PARTRIDGE WAY

ELEVATION CHANGE PROPOSAL

NMA Submission HGY/2021/2075

REVISION: P1

EXISTING PLANNING ELEVATION

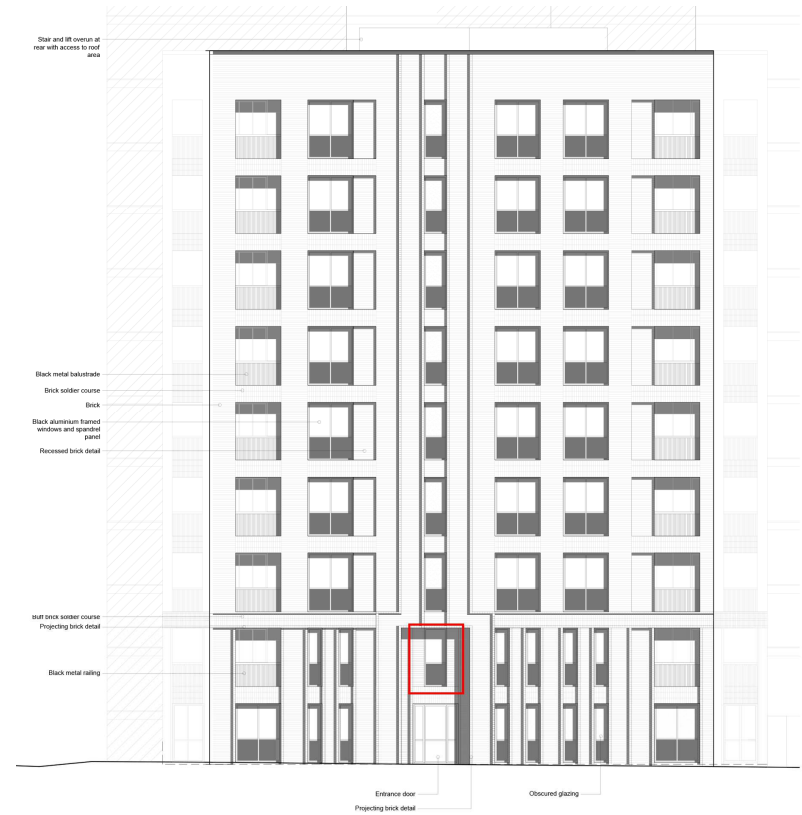
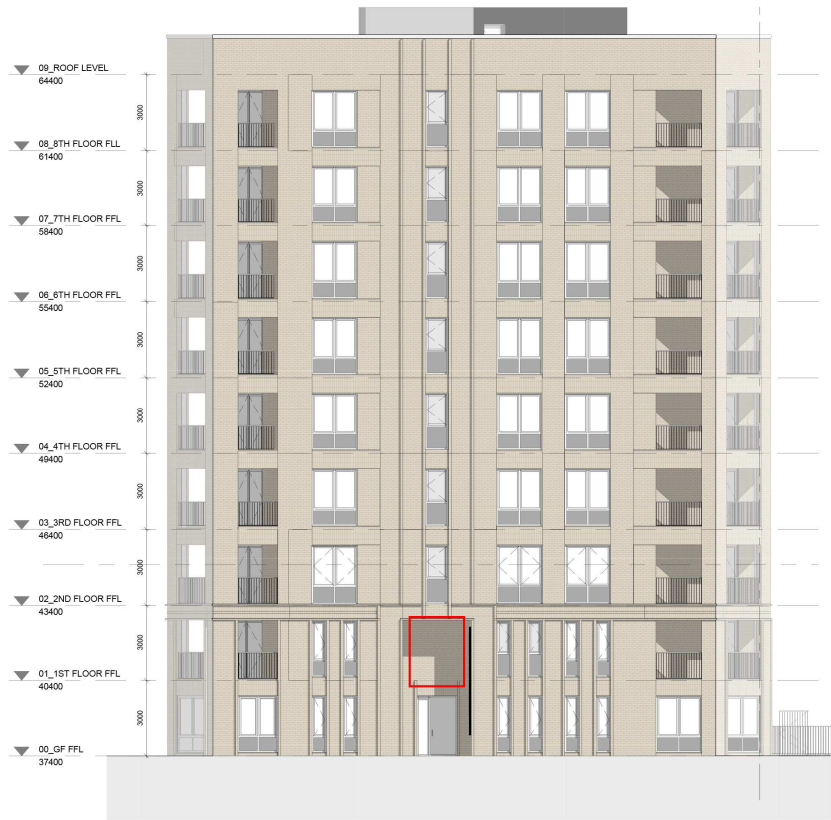
This proposed change to the planning permission HGY/2021/2075 has the intention to comply with the spatial requirements of the Partridge Way development. The window above the entrance in the South West Elevation is proposed to be omitted and replaced with brick.

The reason for this change is the addition of an utility cupboard in the flat layout, above the entrance, in order to comply with the spatial requirements. Furthermore, the window is located in a dark position, as it steps in in the building, and in a public view above the main entrance of the building.
